**REACTOR VESSEL MATERIAL SURVEILLANCE
PROGRAM FOR INDIAN POINT UNIT NO. 2
ANALYSIS OF CAPSULE V**

**FINAL REPORT
SwRI Project No. 17-2108
(Revised)**

March 1990

FIGURE 1
INDIAN POINT UNIT II
INSTALLATION AND REMOVAL
SEQUENCE AND PROPOSED FUEL
SHUFFLE STEPS:

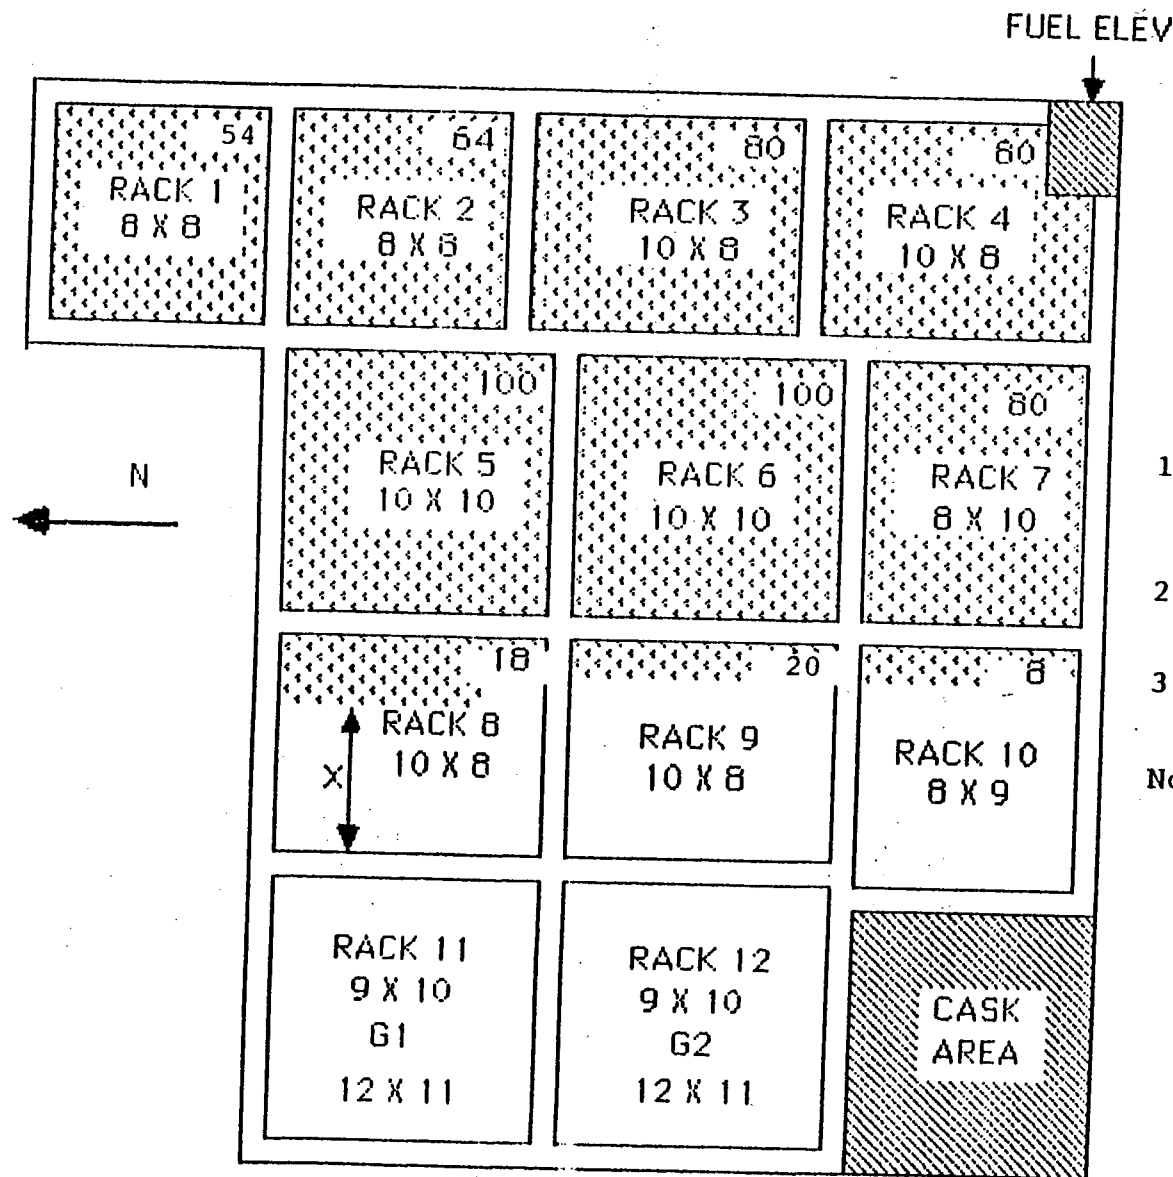
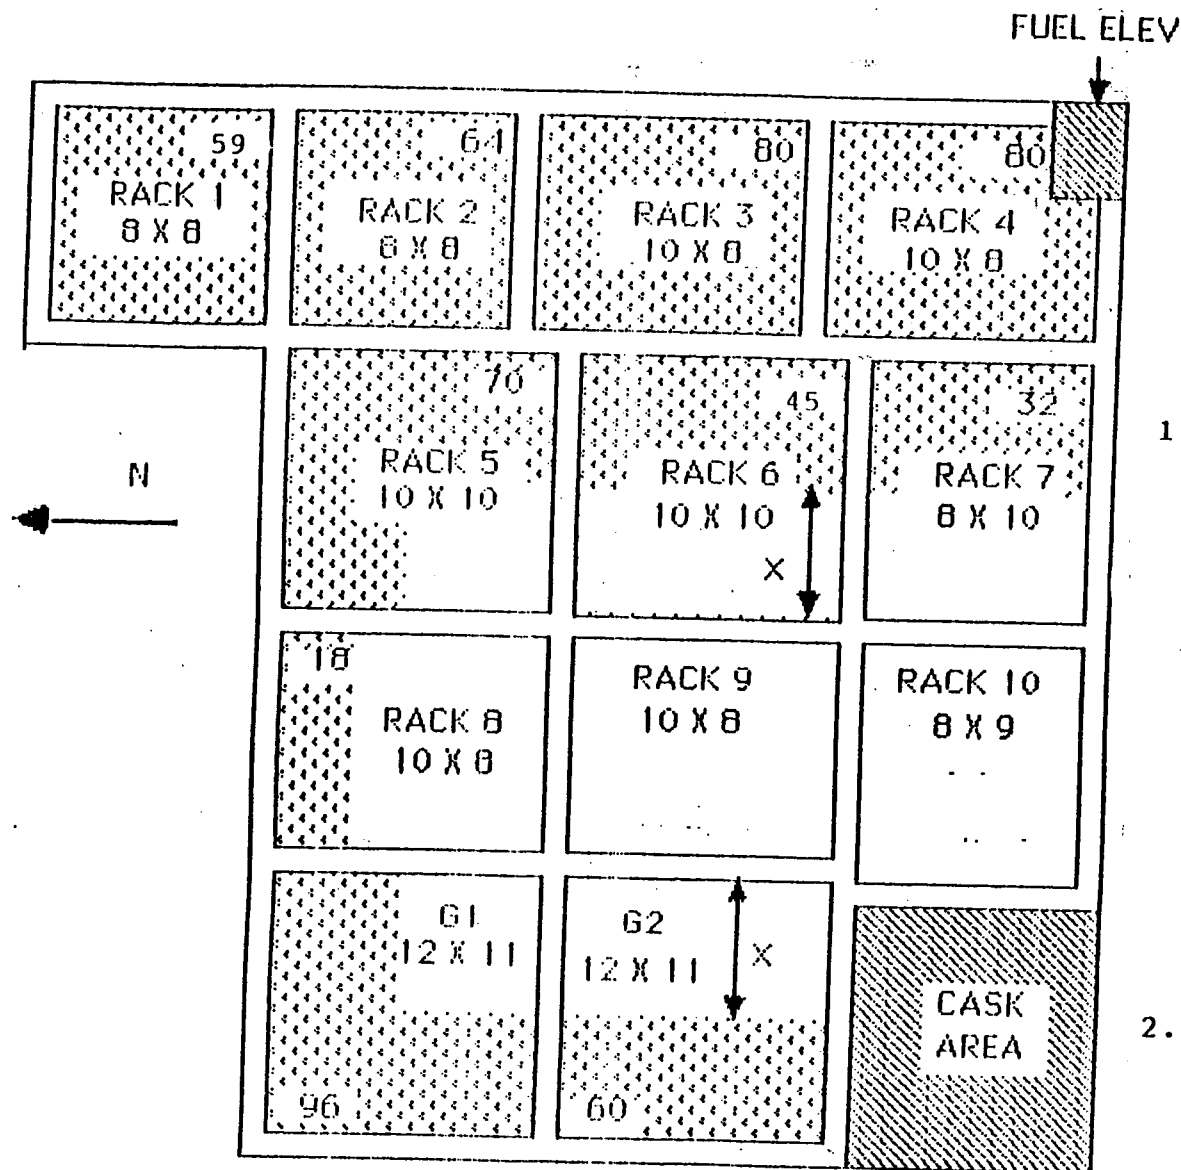
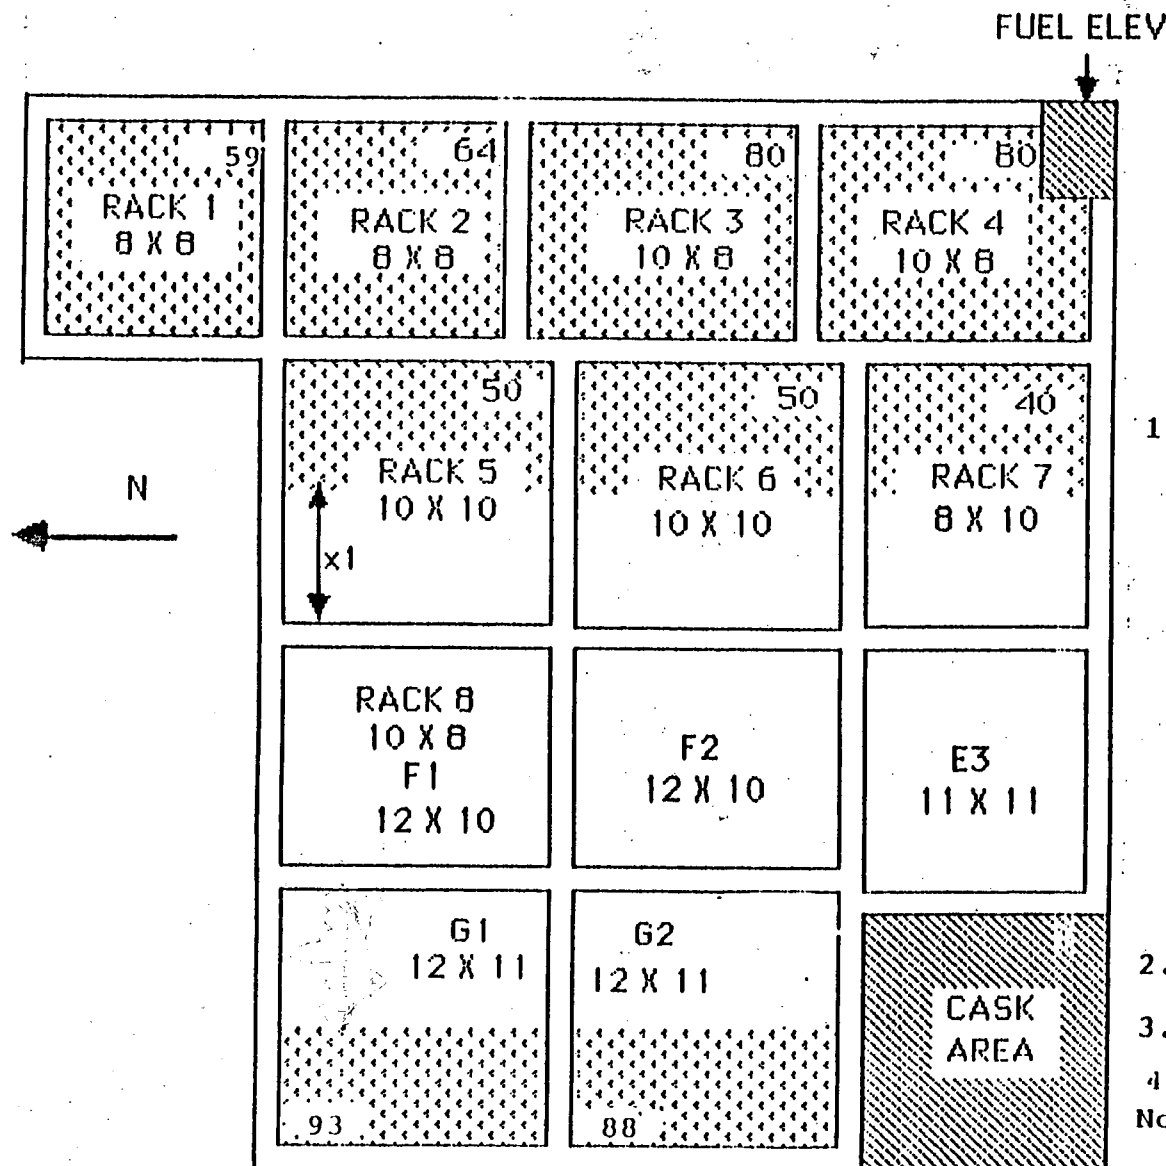
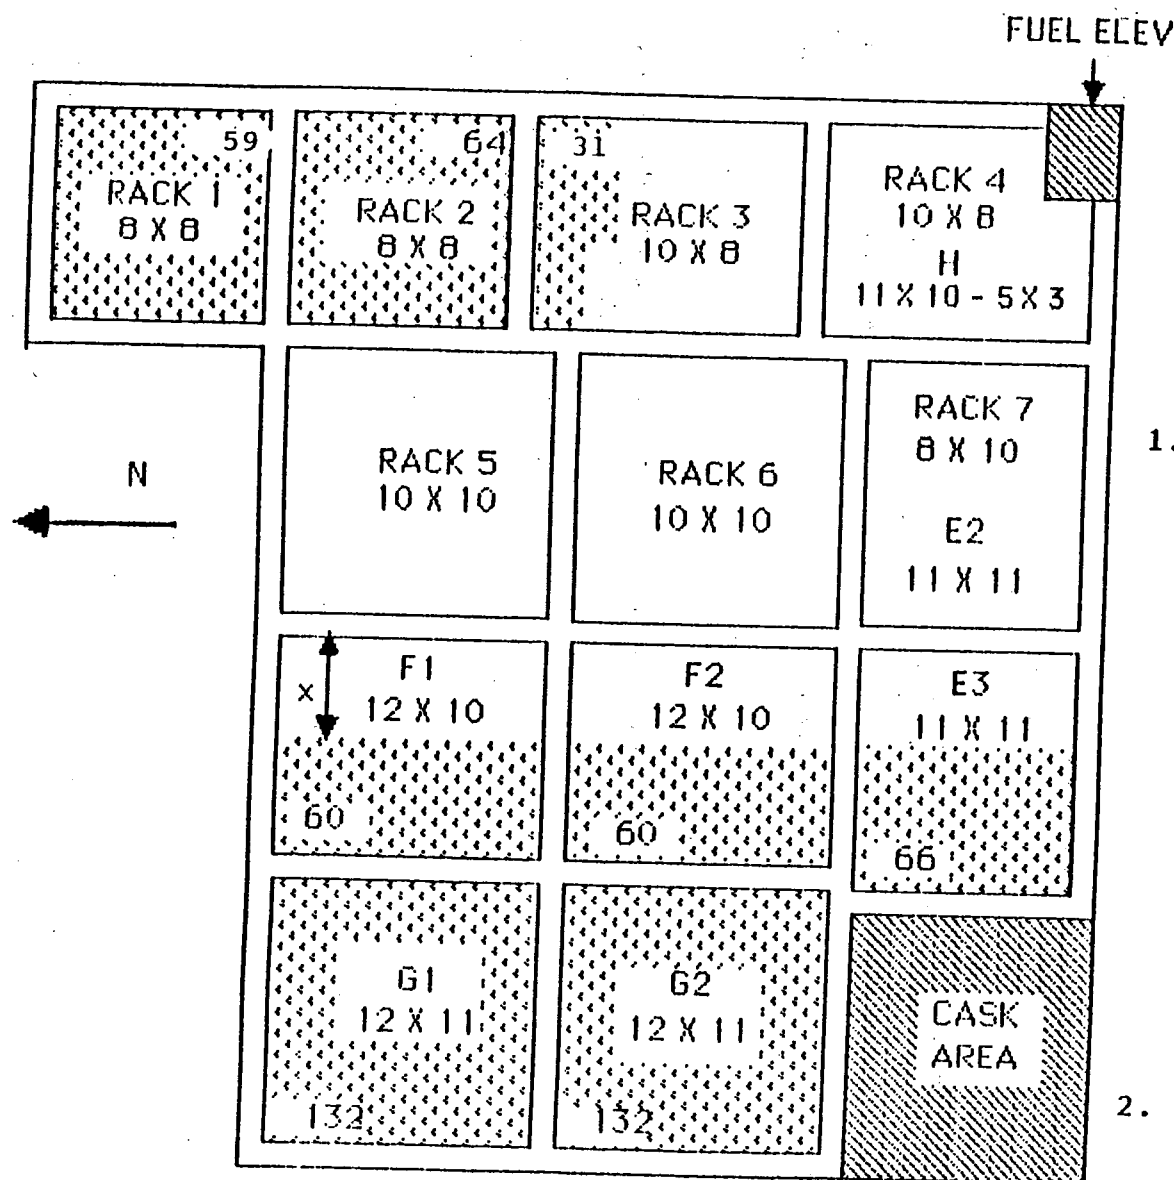
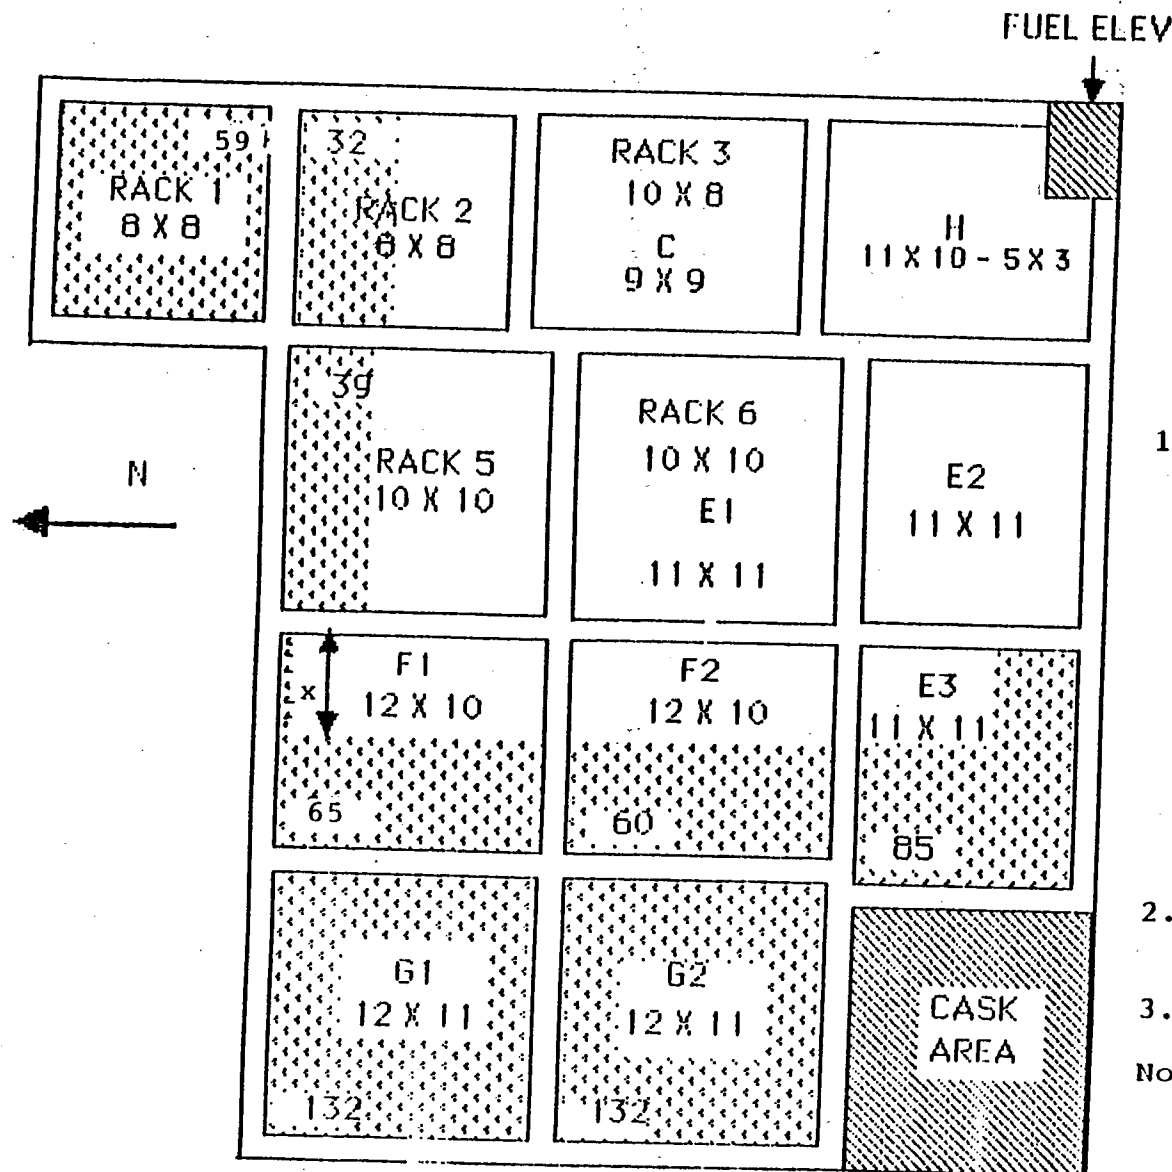
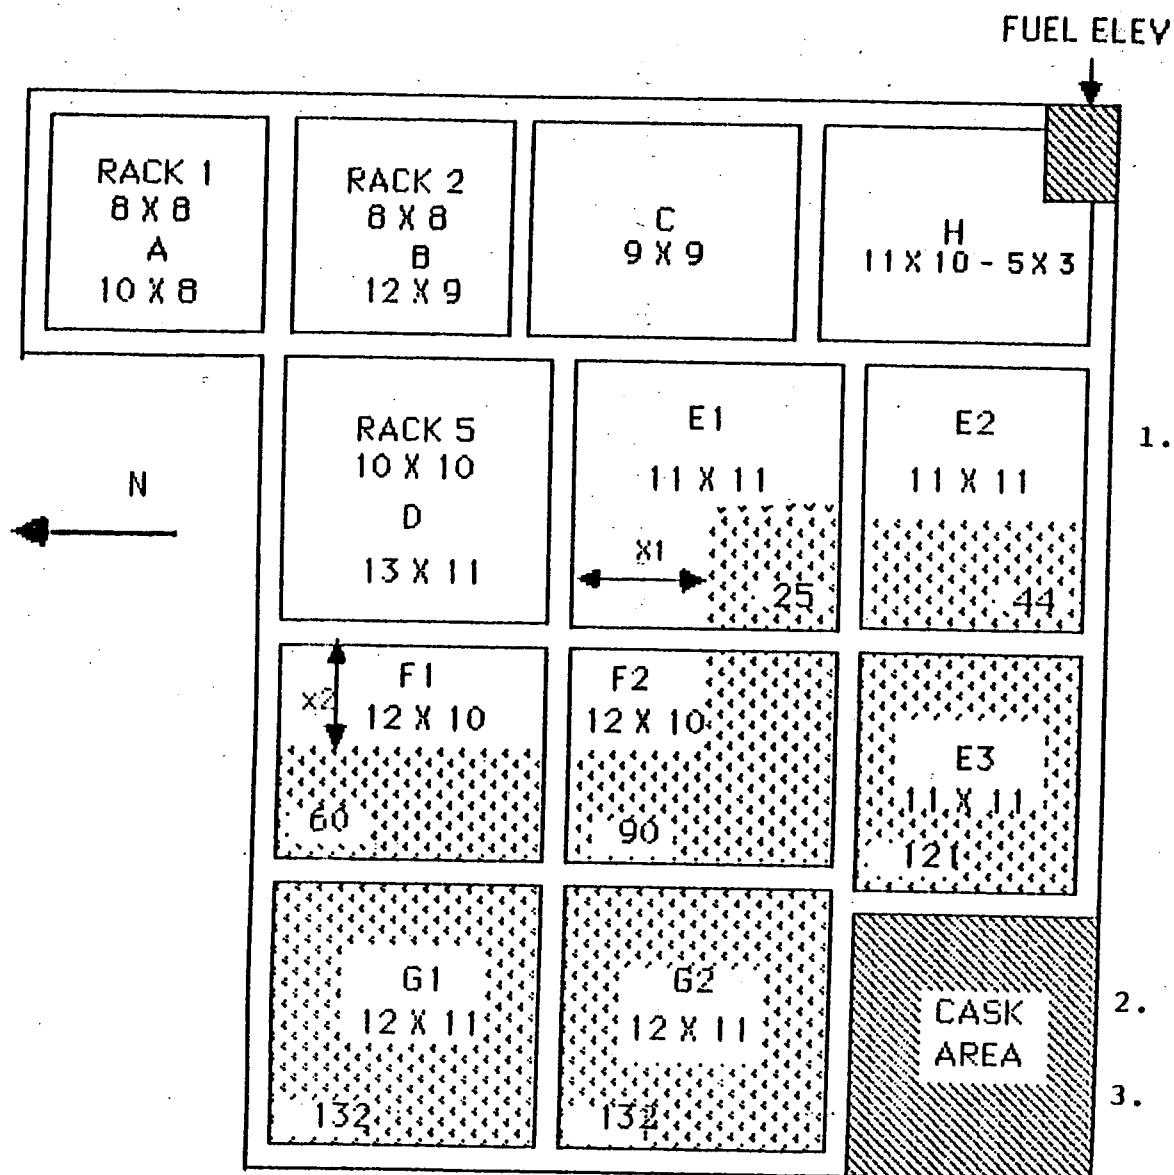
2. Provide information on the procedures for removing the existing racks and installing new racks including the possibility of rack drop on the pool floor or a wall.

The removal of old racks and installation of new racks will be carried out using written procedures which will be reviewed and approved in accordance with the Indian Point 2 review process before use. A list of activities that will be covered by procedures is provided below along with brief explanatory notes, where necessary, for clarification.

The detailed procedures for the above activities are currently under preparation and review by Con Edison. The removal and installation of the racks involves a carefully planned sequence of fuel assembly relocation followed by old rack removal and new rack placement. Figures 1 through 6 show the sequence of rack regions occupied by fuel, racks removed and racks installed in the pool. Old racks are indicated by numerals 1 through 12. New racks are designated by alphanumeric identifications used in the Licensing Report. The dimension x (with subscripts where necessary) indicates the shortest distance between the fuel and the new racks at each reracking stage. These figures provide proposed fuel shuffles which meet the objective of maintaining a minimum distance of four feet between stored fuel and a rack being installed. The final reshuffling plan may differ somewhat from Figure 1 through 6, but the objective of maintaining the minimum distance of four feet will be met.

In the unlikely event that a rack was dropped, a thorough inspection of the affected area including but not limited to the pool liner, potentially damaged racks, and the spent fuel cooling system would be done with remote inspection equipment such as underwater cameras. If necessary, divers would be utilized to augment and/or verify the remote inspection. Based on the inspection results an action plan and associated procedures would be developed to correct any deficiencies identified.

FIGURE 3.5 ADJUSTABLE SUPP'T.

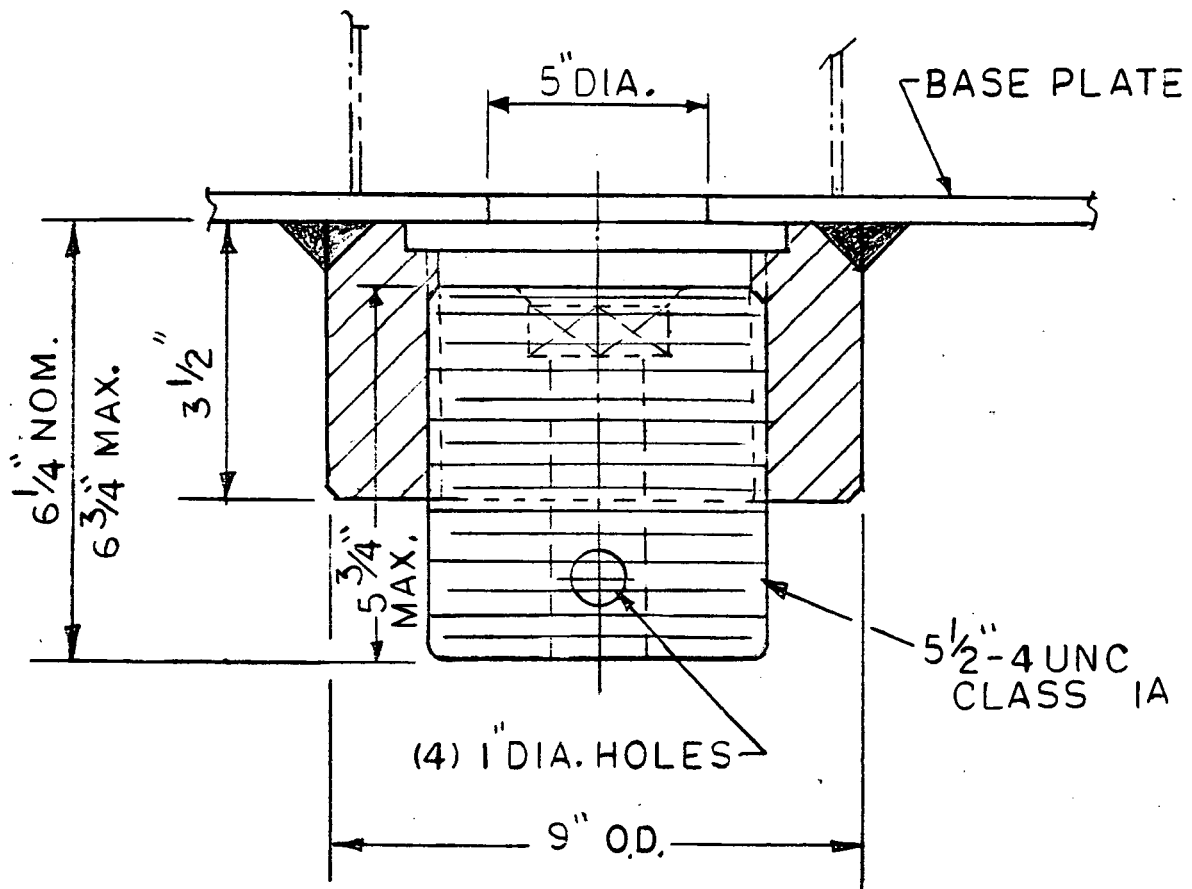
3. Page 3-13, Figure 3.5

The racks will be arranged in two regions in the spent fuel pool. Region I will have 269 locations capable of storing unirradiated fuel of up to 5.0 wt% U-235 initial enrichment. Region I has enough locations to store a full core discharge and one-third core of unirradiated fuel. Region II will have 1105 locations for storage of fuel which meets enrichment and burnup criteria developed as part of the rack design. Section 4 of this report addresses this in more detail. In addition, there are two locations for storage of failed fuel canisters. The total number of storage locations, as detailed above, is 1376.

The module's four support legs are remotely adjustable. Thus, the racks can be made vertical and the top of the racks can easily be made co-planar with each other. The rack module support legs are engineered to accommodate variations of the pool floor. The placement of the racks in the spent fuel pool has been designed to preclude any support legs from being located on the liner welds. Support pads have been provided to bridge any obstructions which could potentially interfere with placement of a rack support leg.
